HOPE BAY PROJECT

Proponent's Response to Comments Received on the 2021 Annual Report and 2021 Annual Geotechnical Inspection Reports

Prepared by
Agnico Eagle Mines Limited

Prepared for
Nunavut Water Board

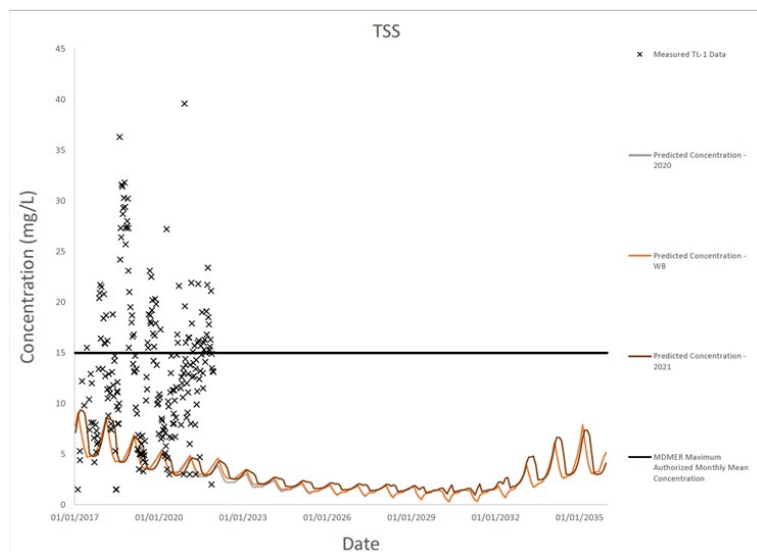
TSS concentrations are not currently evaluated as part of the model predictions as parameters are treated conservatively by the model. As it currently stands TSS concentrations are underpredicted by the model therefore, settling does not appear to be a problem of model predictions. Furthermore, TSS concentrations at the TIA exceed MDMER criteria.

It would be of benefit to AEM if they were to evaluate predicted model TSS concentrations as they are currently under predicted and concentrations at the TIA exceeded MDMER criteria in October of 2021.

Mass balance modelling predicts fully mixed concentrations, and treats all parameters as conservative, in that they do not undergo any assimilation (uptake, transformation, settling) reactions after discharge. It does, however, provide a conservative calculation of fully mixed concentrations in the receiver. Therefore, all parameters, not just TSS, would be treated conservatively. AEM has modeled TSS and provide outputs as plotted in Attachment 2 (reproduced below). The

35.6 RESPONSE TO KIA-NWB-27

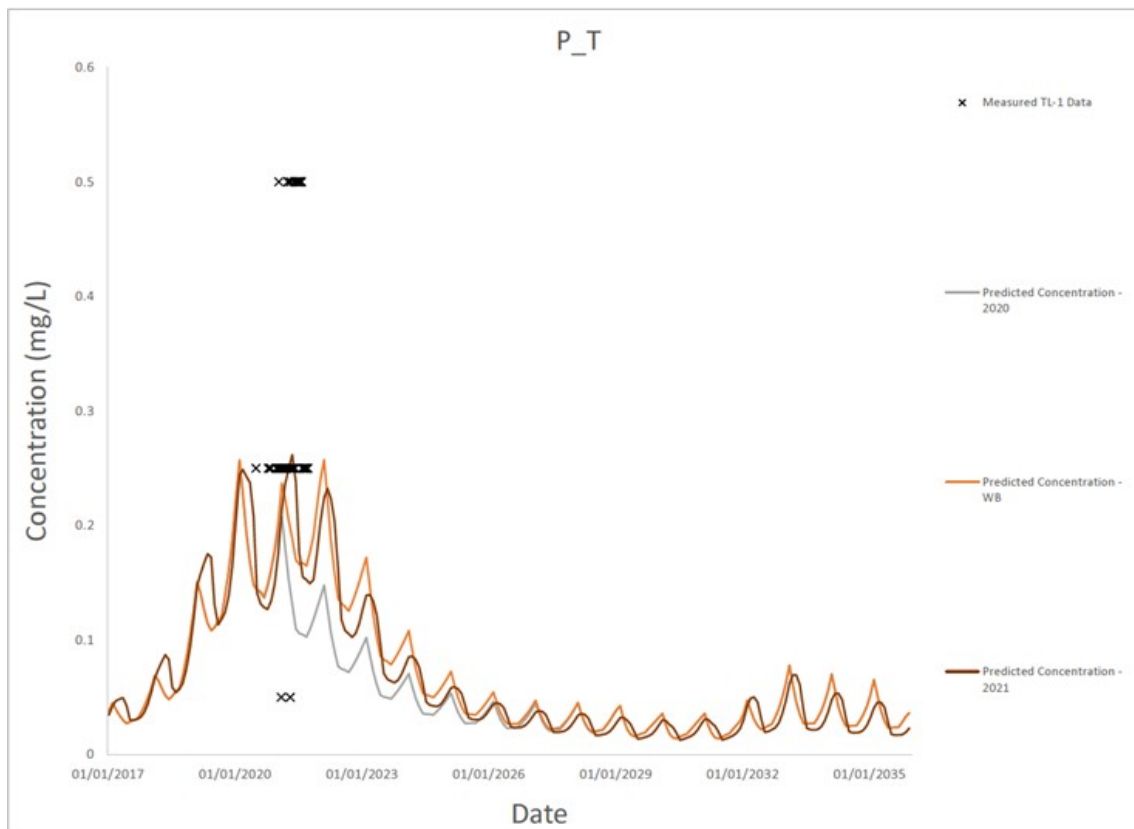
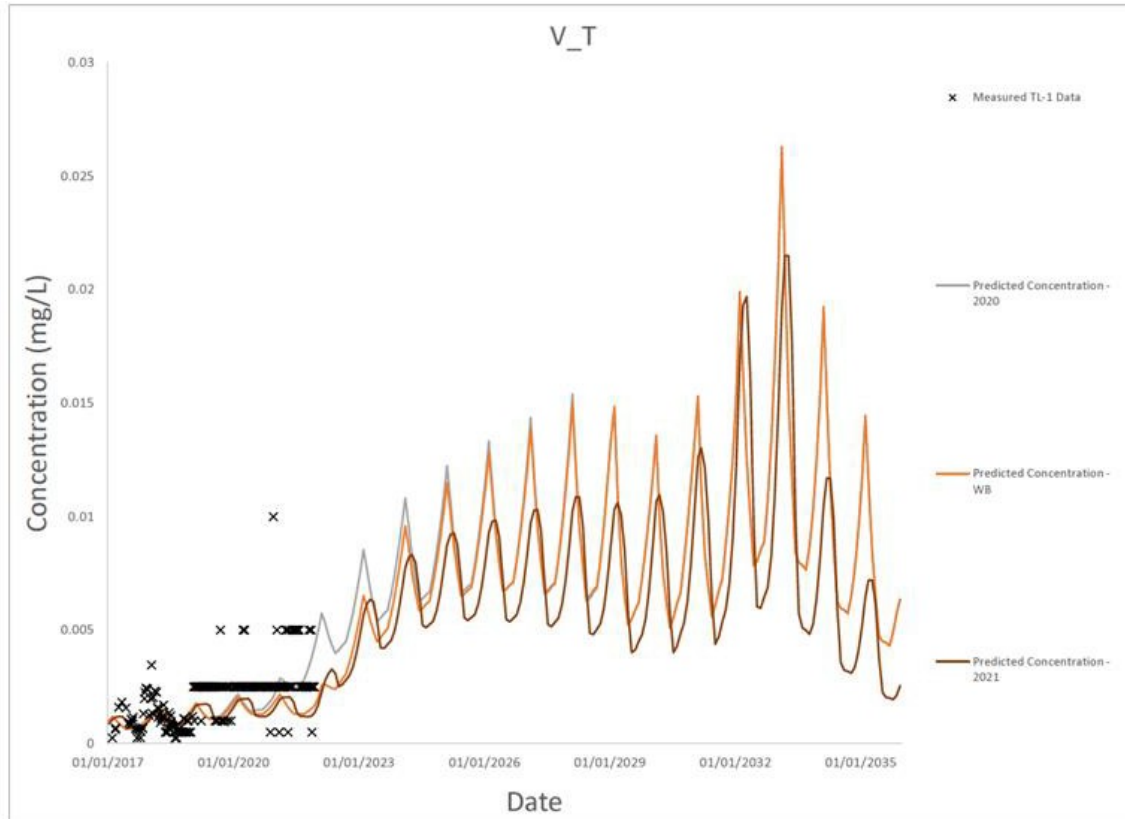
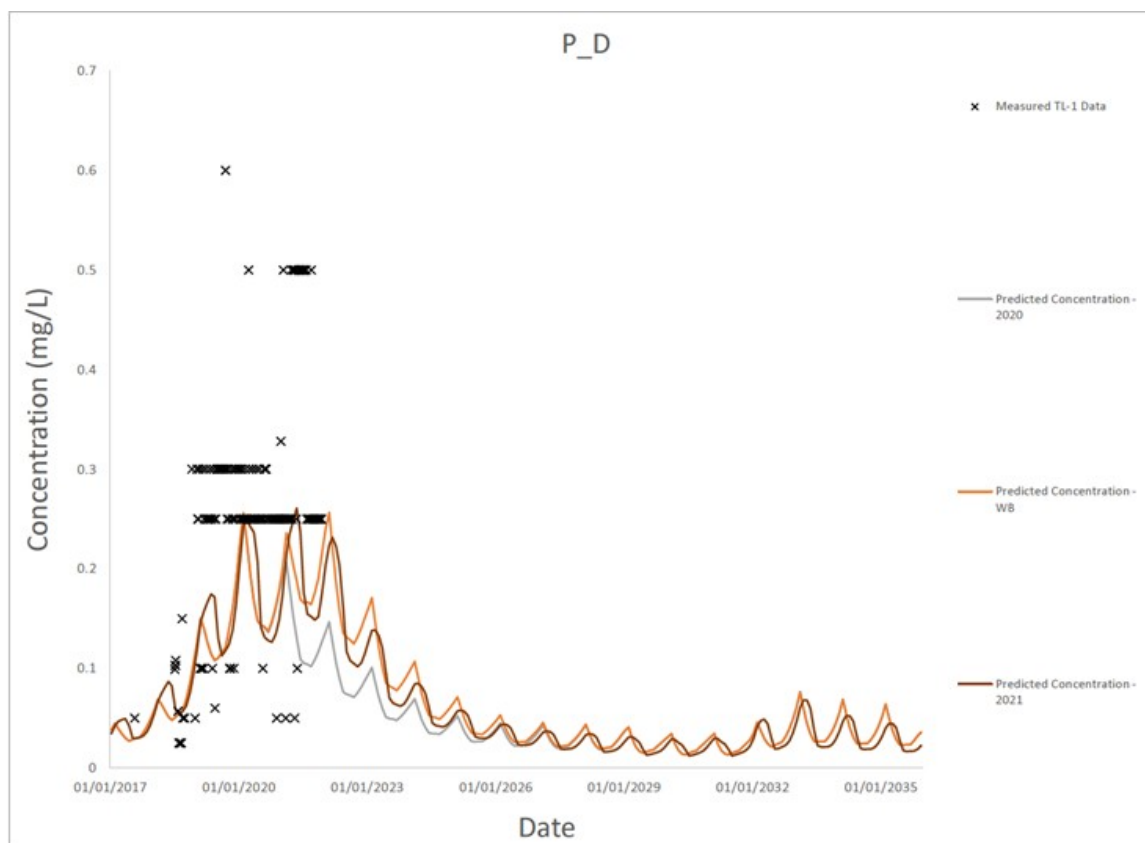
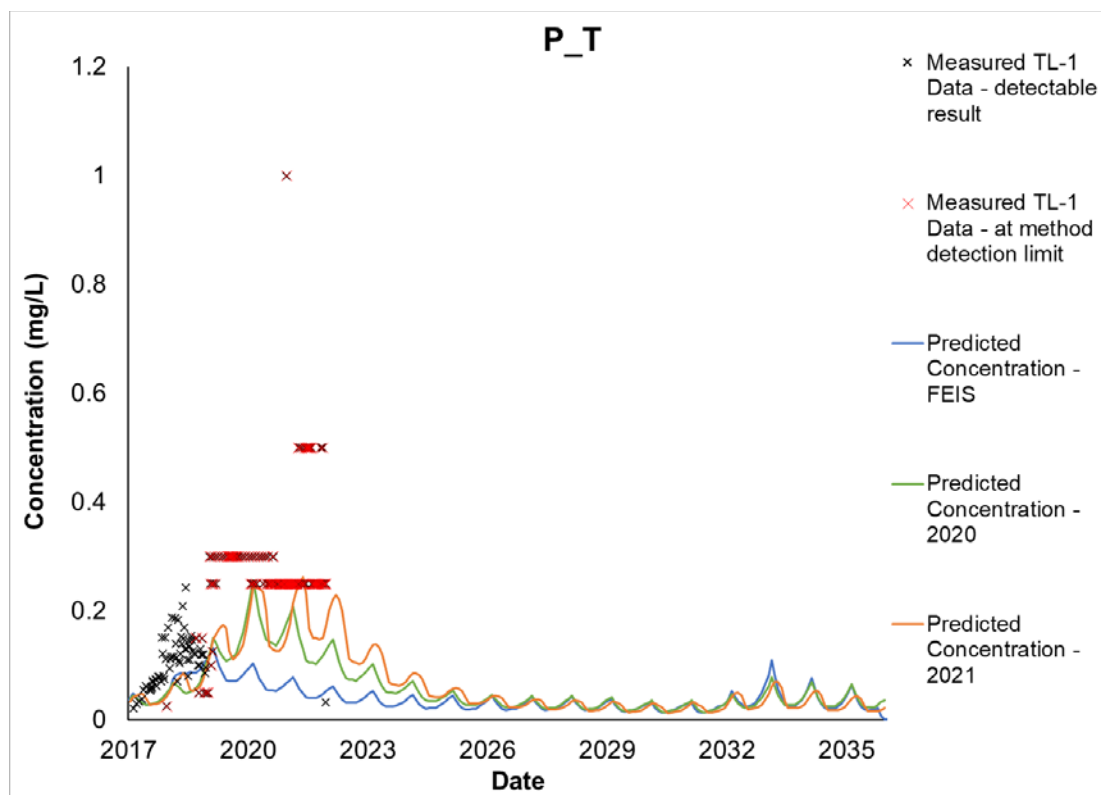
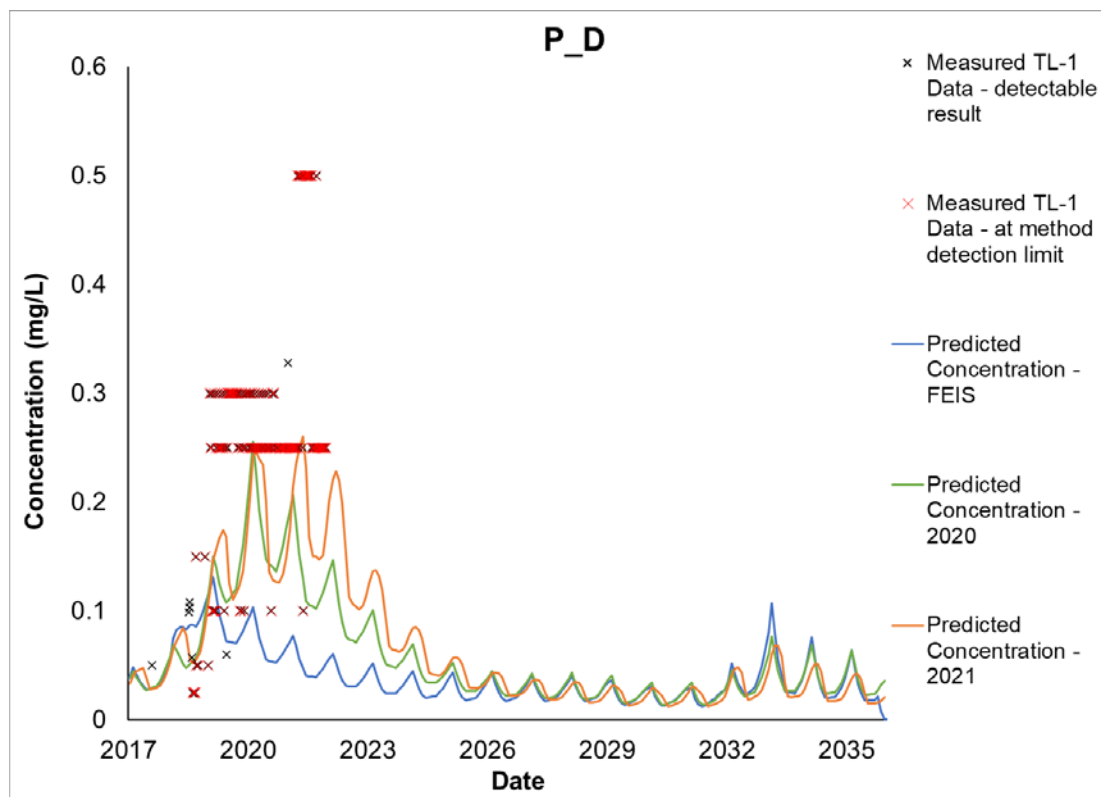
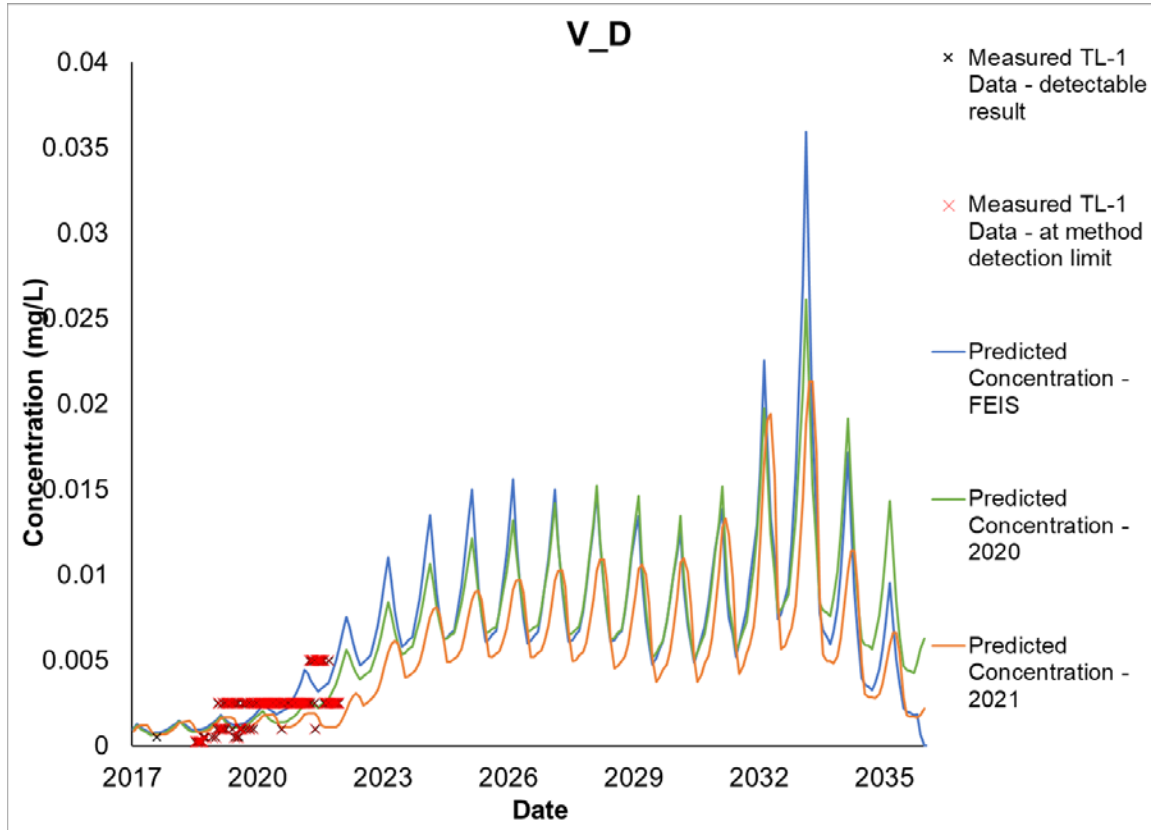
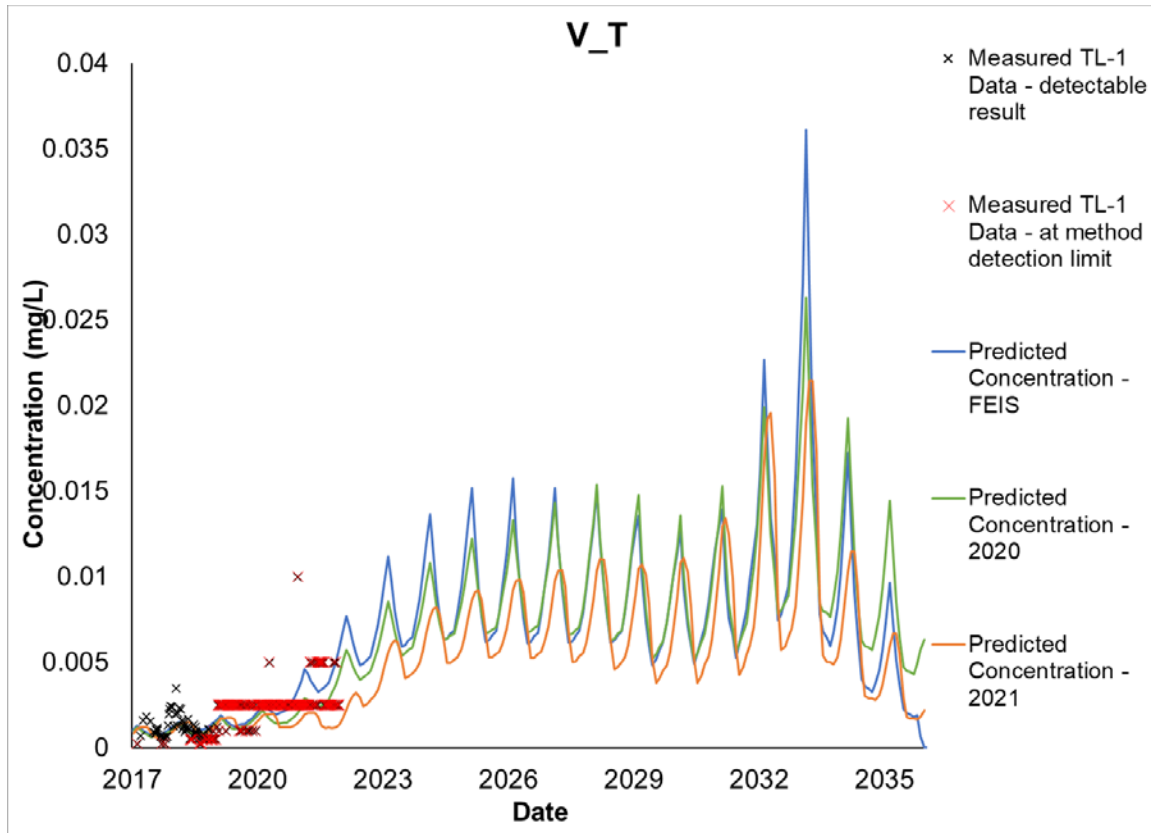
Several measured concentrations of total and dissolved phosphorus and total vanadium were greater than predicted concentrations in both 2020 and 2021. However, these values were considered conservative (measured values below model predictions), no efforts were made to explain the discrepancy between measured and predicted results and no efforts were made to correct the model predictions.

According to Section 2.2, Table 7 in the 2021 report: Initial Screening Assessment of Water Load Balance Parameters (reproduced below), concentrations of total and dissolved phosphorus, and total vanadium were all categorized indicating “measured values are below model predictions”. Plots presented in Attachment 2 of the Annual Water Load and Balance Assessment show a large number of measured values above the predicted concentration line. Parameters that were considered

underpredicted were carried forward in the assessment and a discussion of corrective actions provided. Since total and dissolved phosphorus, and total vanadium were not classified as underpredicted, they were not carried forward in the analysis and no corrective actions were discussed for the greater than predicted concentrations. It is recommended that AEM provide a more detailed definition of classification types (number of measured values greater than the predicted value to be considered underpredicted) to support the classifications provided, indicate if the detection limit is greater than prediction for these parameters or reclassify total and dissolved phosphorus and total vanadium. A discussion should be provided for these parameters regarding the potential causes for the underprediction, potential corrective measures if necessary, and improvements to model outputs.

It is recommended that AEM provide a more detailed definition of classification types (number of measured values greater than the predicted value to be considered underpredicted) to support the classifications provided or reclassify total and dissolved phosphorus and total vanadium. A discussion should be provided for these parameters regarding the potential causes for the underprediction, potential corrective measures if necessary, and improvements to model outputs. It is noted that this was identified in the review of the 2020 annual report and continued to be a problem for the 2021 annual report.

The classification approach is mainly qualitative, as described in the response to KIA-NWB-23, and more detail will be provided in future annual reports to support classifications.

In Table 7 (Initial Screening Assessment of Water Load Balance Parameters) in Section 2.2 of the 2021 report, parameters with measured values at the MDL and greater than the prediction line were presented together with conservatively predicted parameters, as noted in the third column ('Comparison to Model Predictions') of the table. In future reports, these parameters will be presented and described separately.

Total and dissolved phosphorus and vanadium are discussed in KIA-NWB-8, and the majority of the measured data have been reported at the MDL (see figures below that highlight MDL results in red). Model inputs have not been updated in recent validation reports (SRK 2021, SRK 2022) as it is unclear how predictions trend with actual concentrations which are obscured by high MDLs. Vanadium and phosphorus predictions will continue to be reviewed and discussed in the 2022 validation, and inputs may be updated should detectable data be reported in 2022.

Note: data was missing from the total phosphorus plot provided in the 2021 annual report. This data is included in the above plot, and the error has been rectified for future reporting
